## **Proposal for a new series of amendments to Regulation No. 83**

### **Submitted by the expert from the European Commission**

**07 series of amendments**

Figure App4/1

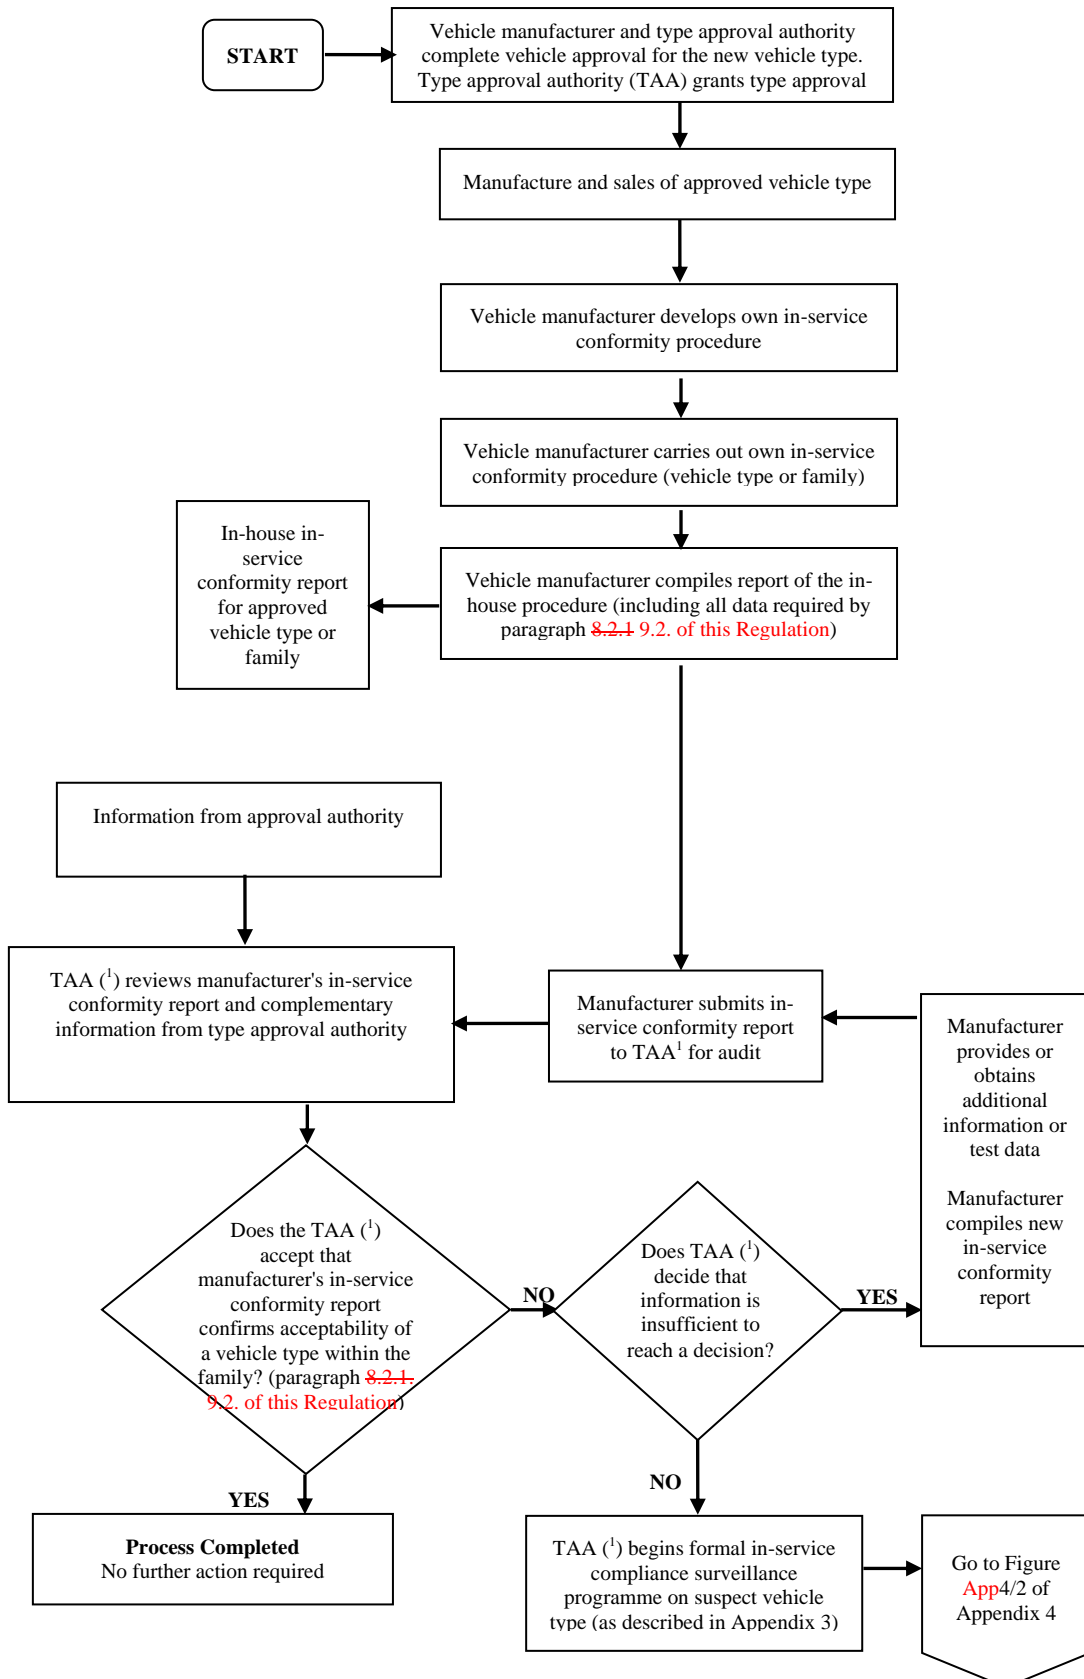
[Editorial note: need to add a cross-reference to this figure in the text]

Figure App5/1

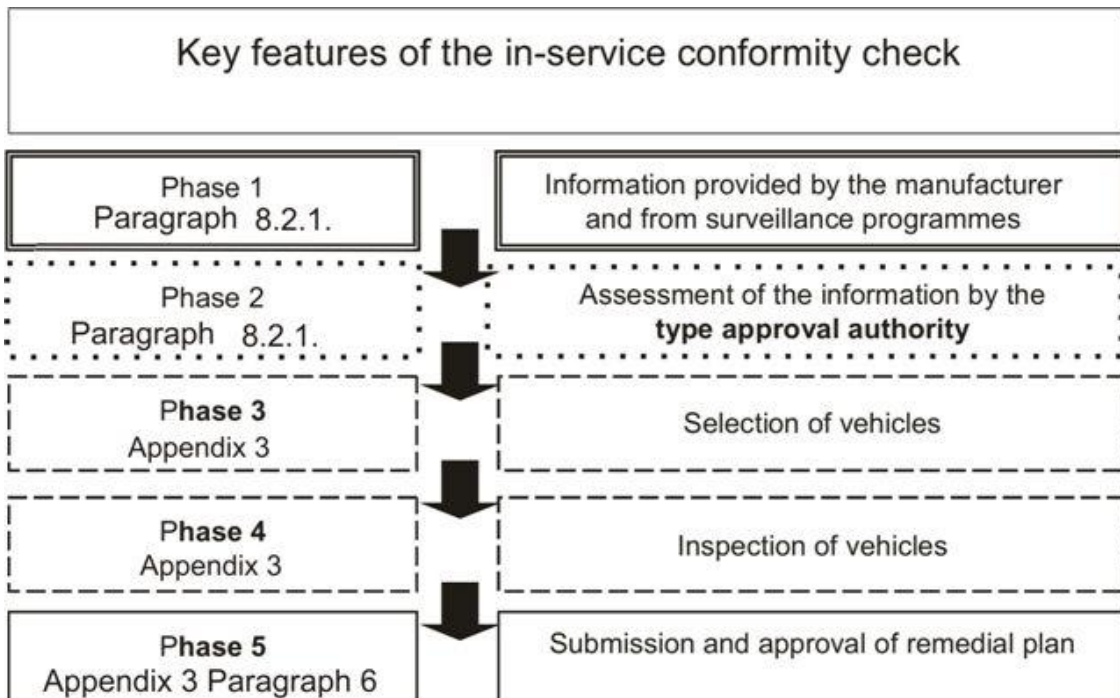
[Editorial note: there are cross-references in this figure that are incorrect. Phase 1 should be paragraphs 9.2. and 9.3. Phase 2 should be paragraph 9.4. New figure needs to be created]

Figure A8/1  
Procedure for low ambient temperature test

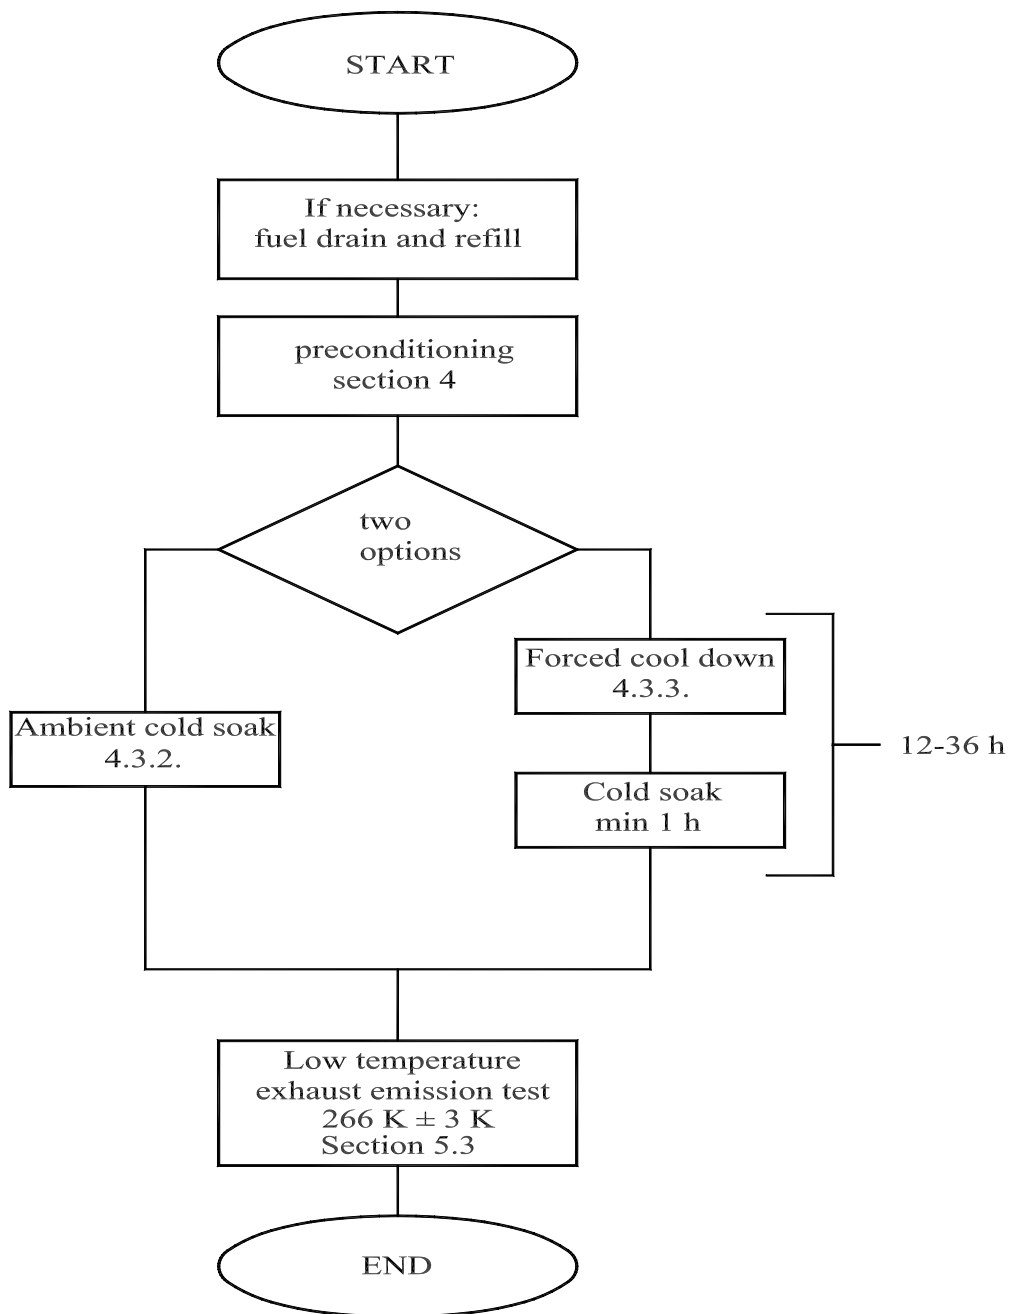
[Editorial note: diagram would benefit from being updated to make it clear what the cross-reference refer to, e.g. “paragraph 4.3.2. of Annex 8”]

Figure A9/1  
 Driving schedule

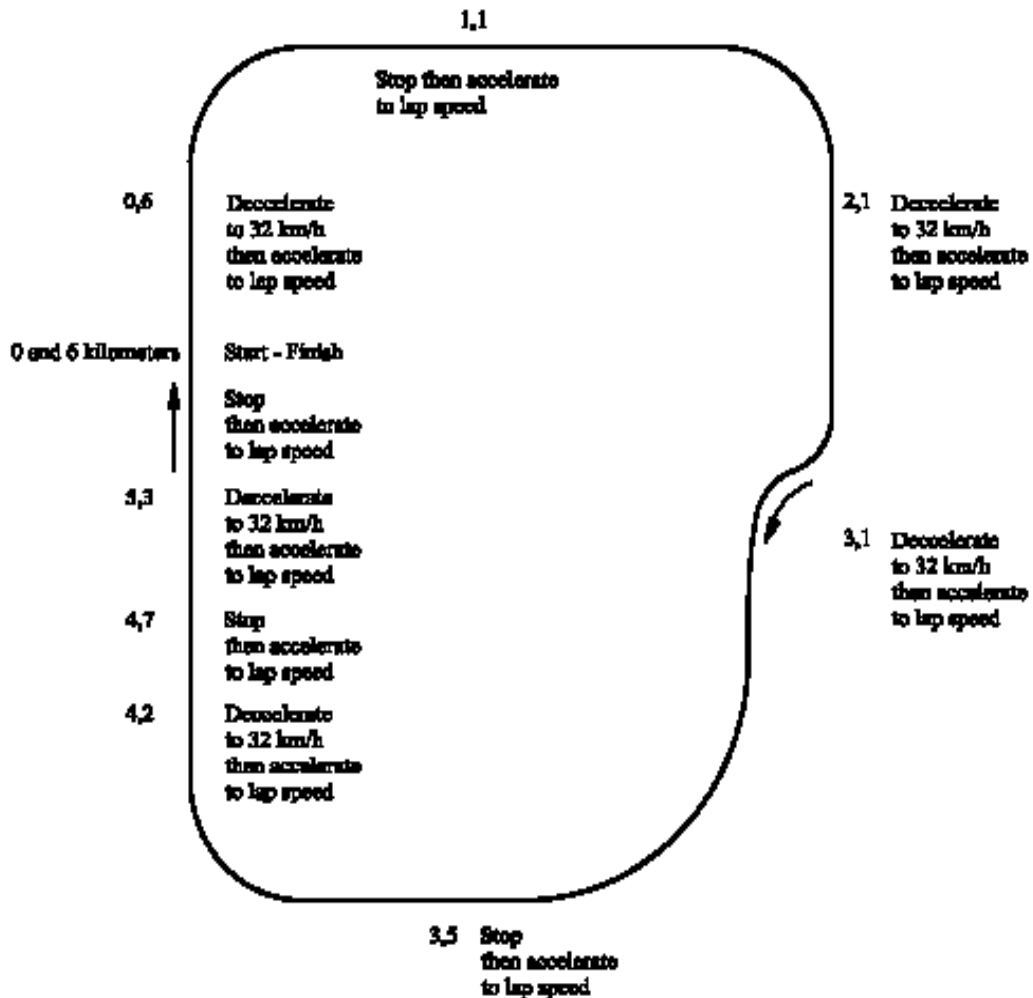
[Editorial note: a better quality image needs to be obtained]

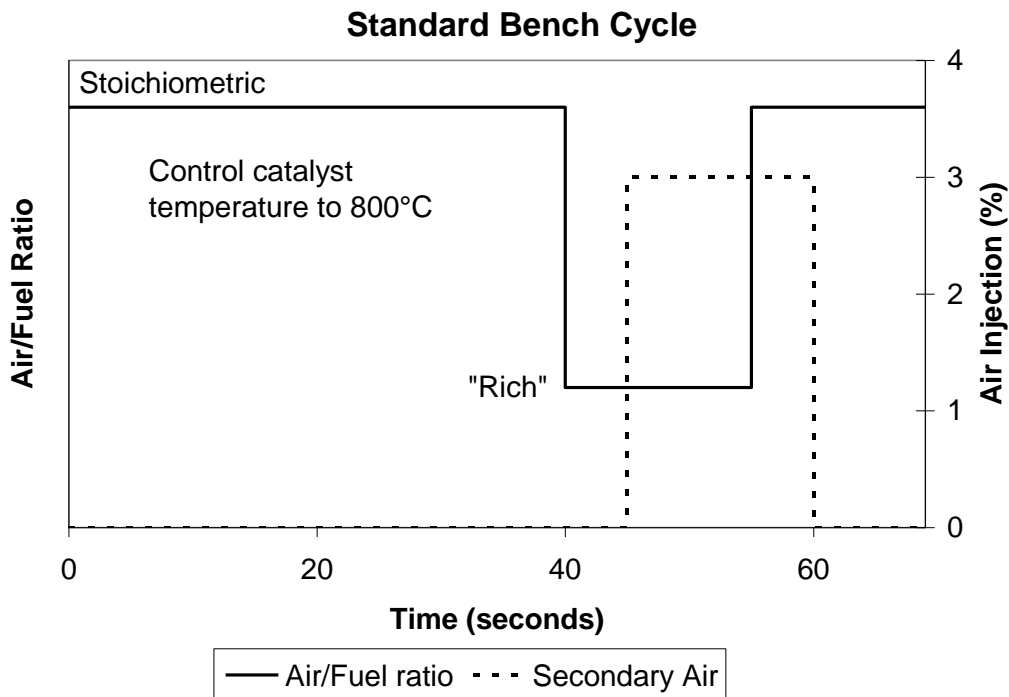
[Editorial note: Figure caption needed for figure that follows. Plus x-ref in text]
